Granite School District
**SILVER HILLS ELEMENTARY
SECURITY REMODEL**
Project No. 2023.030.00

ADDENDUM NO. 1
January 23, 2024

The original specifications and drawings, dated October 31st, 2023 for the project referenced above are amended in the Addendum No. 1, dated January 23, 2024.

FLOOR & RCP ELECTRICAL PLANS

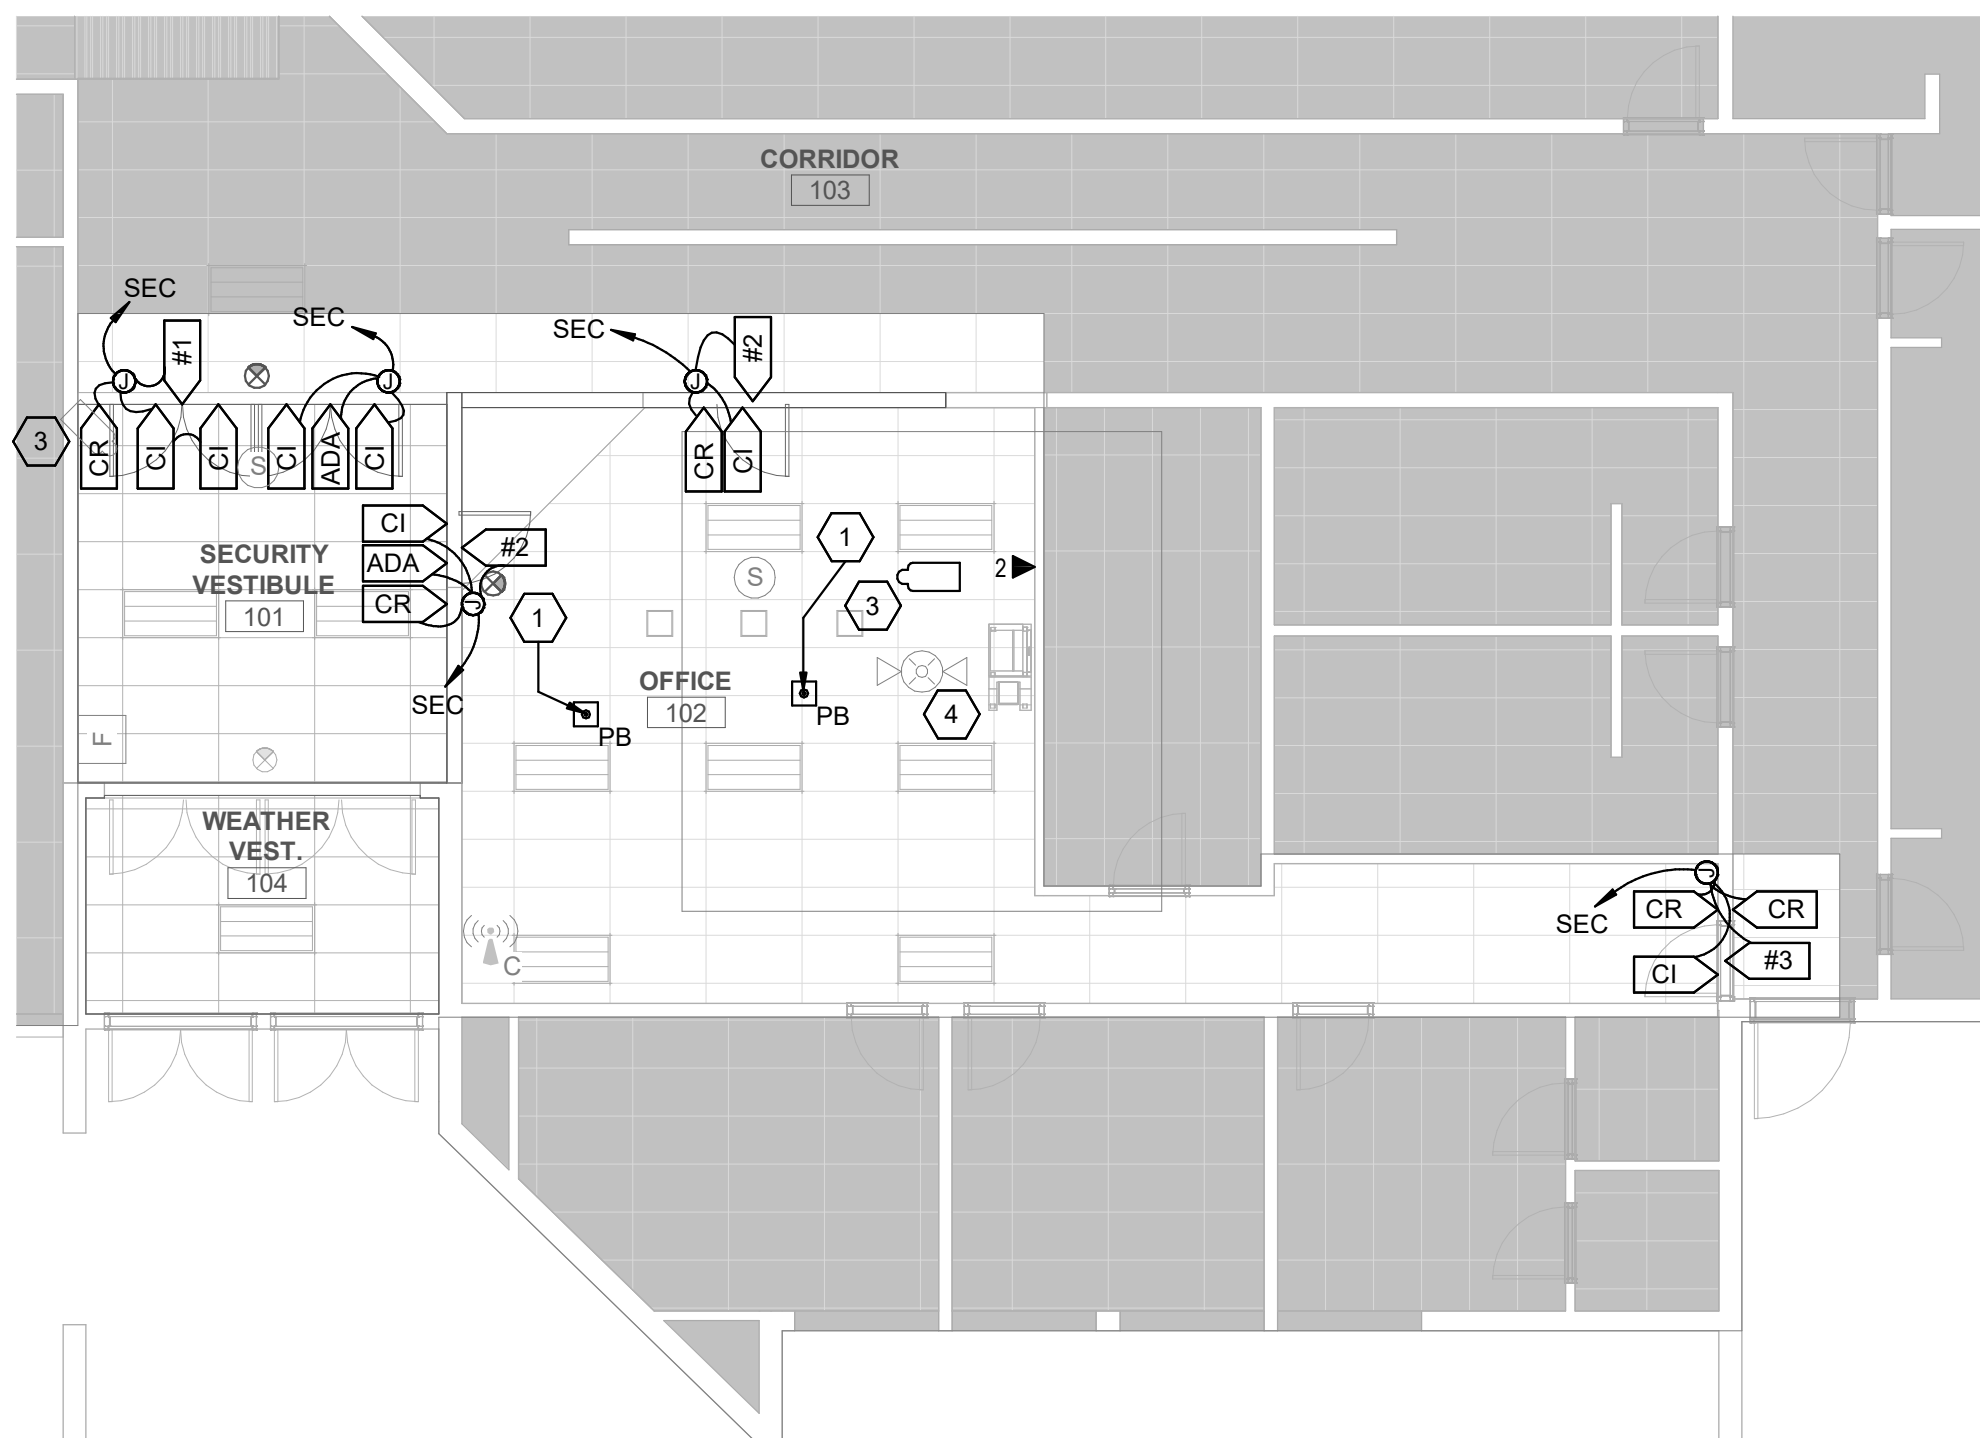
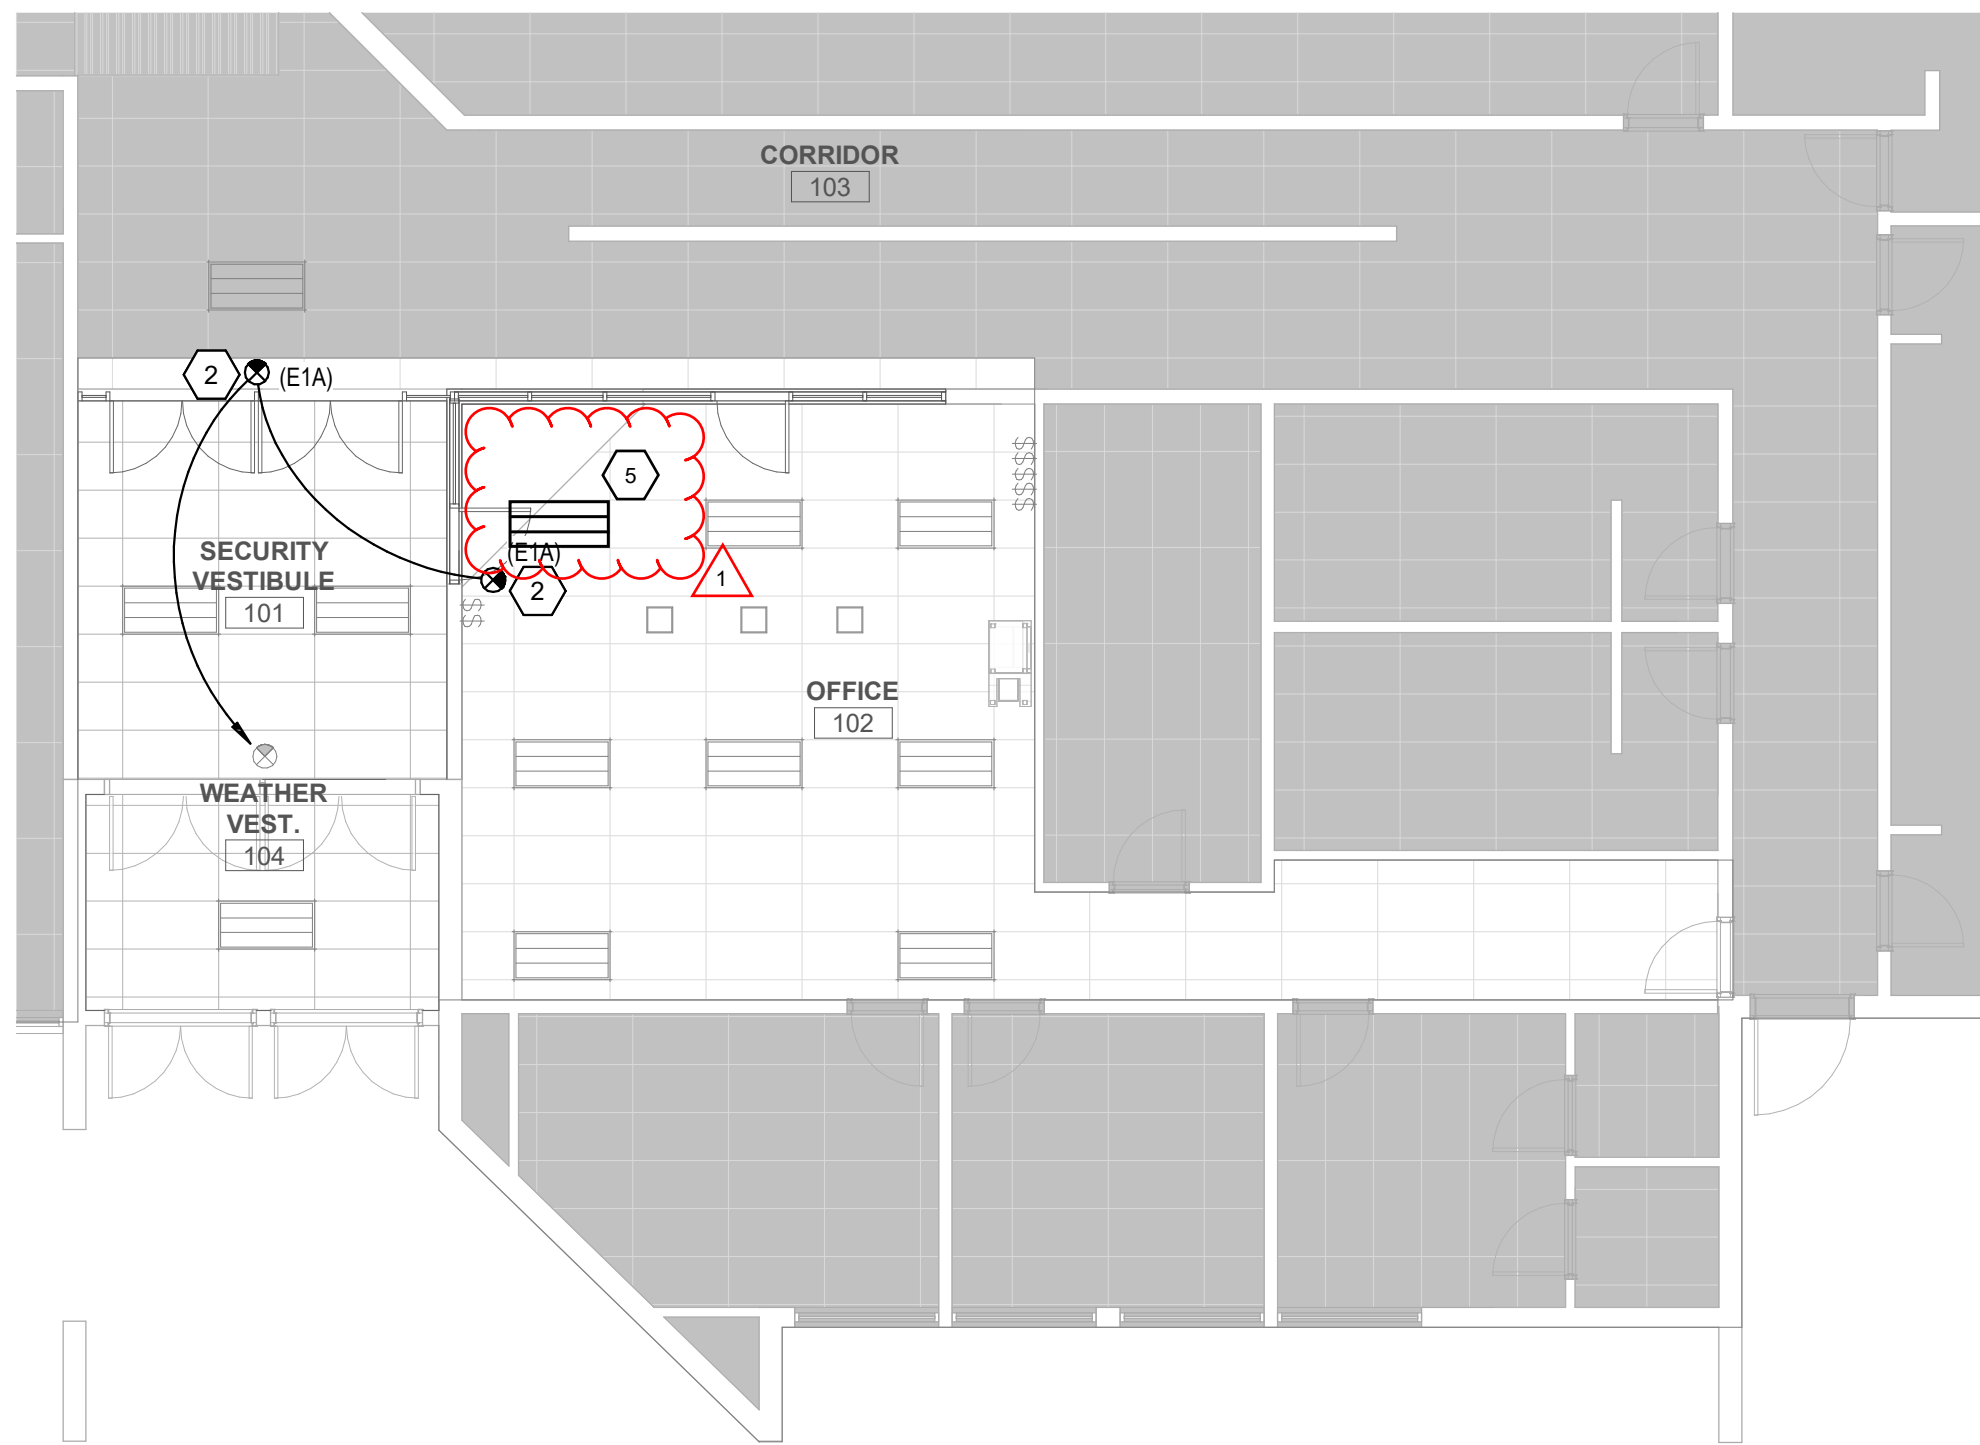
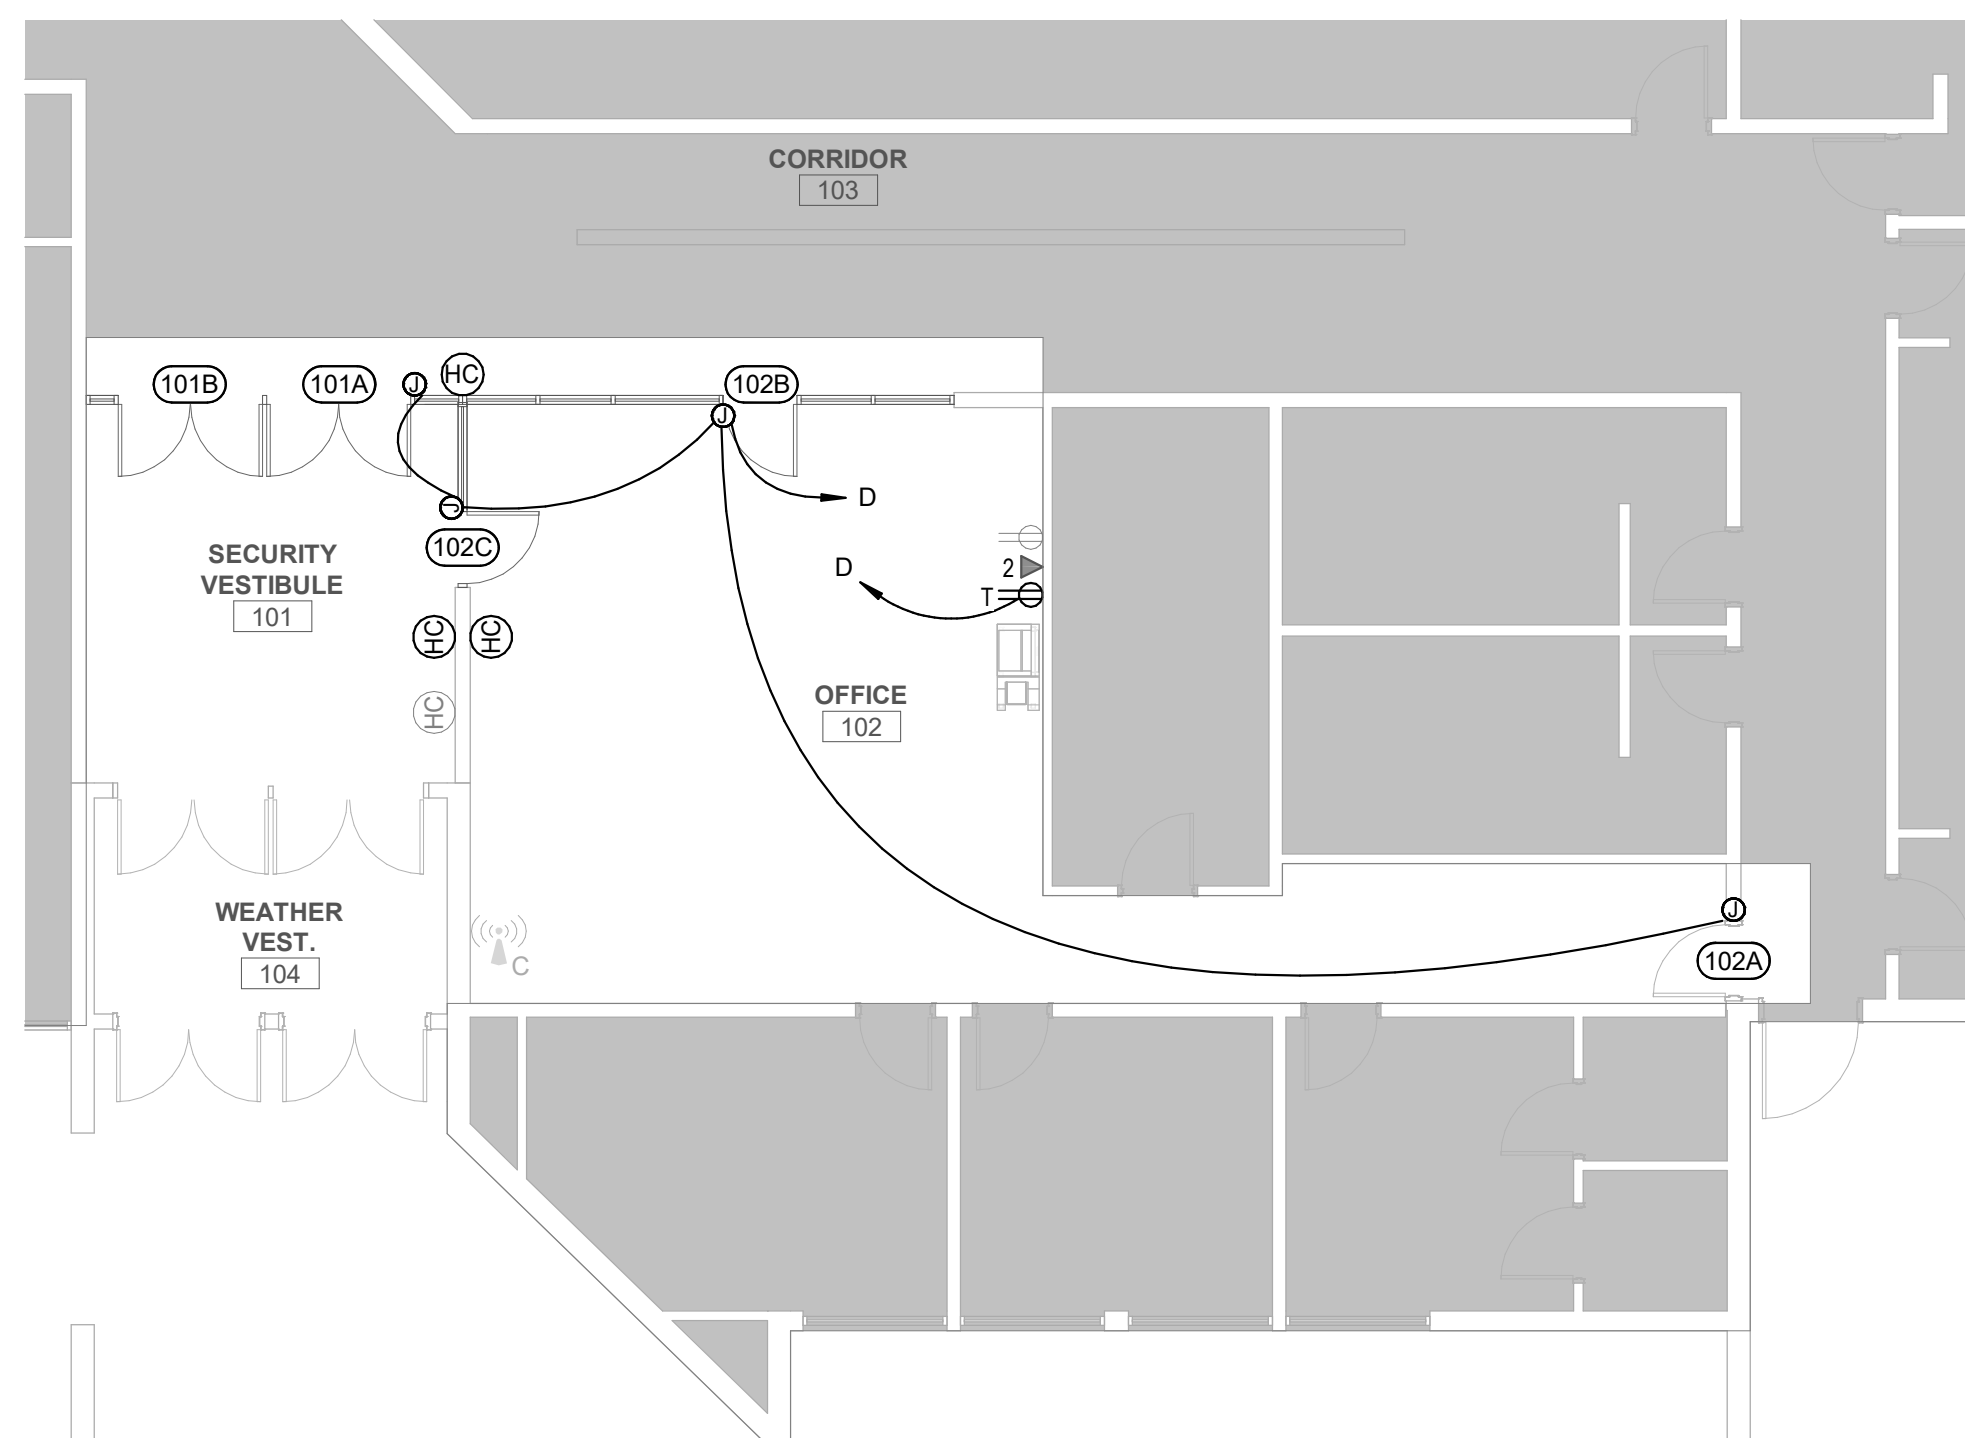
AD1-02 – Sheet EP110. Light fixture added and keynote clarification.

- 1 PROVIDE WIRELESS PUSH BUTTON TO ACCESS CONTROL SYSTEM FOR DOOR RELEASE MOUNTED IN MILLWORK. CONTRACTOR TO COORDINATE WITH DISTRICT AND PROGRAM RELEASE BUTTONS PER DISTRICTS DIRECTION. COORDINATE WITH MILLWORK PROVIDER FOR EXACT MOUNTING LOCATION IN MILLWORK.
- 2 CIRCUIT NEW EXIT LIGHT FIXTURE TO EXISTING EXIT LIGHTING CIRCUIT WITH CAPACITY.
- 3 EXISTING CAMERA TO REMAIN. CONTRACTOR TO COORDINATE WITH DISTRICT TO REMOVE AND REINSTALL CAMERA IN NEW CEILING TILE AS REQUIRED.
- 4 EXISTING BLUE STROBE CO NOTIFICATION DEVICE TO REMAIN
- 5 PROVIDE NEW LIGHT FIXTURE TO MATCH EXISTING FIXTURE IN OFFICE SPACE. FIXTURE SPECIFICATION: PHILIPS EVOGRID; 3800 LUMENS; 4000K; ROUND RIBBED DIFFUSER. CIRCUIT NEW LIGHT TO EXISTING CIRCUITING AND CONNECT TO EXISTING CONTROLS IN OFFICE.
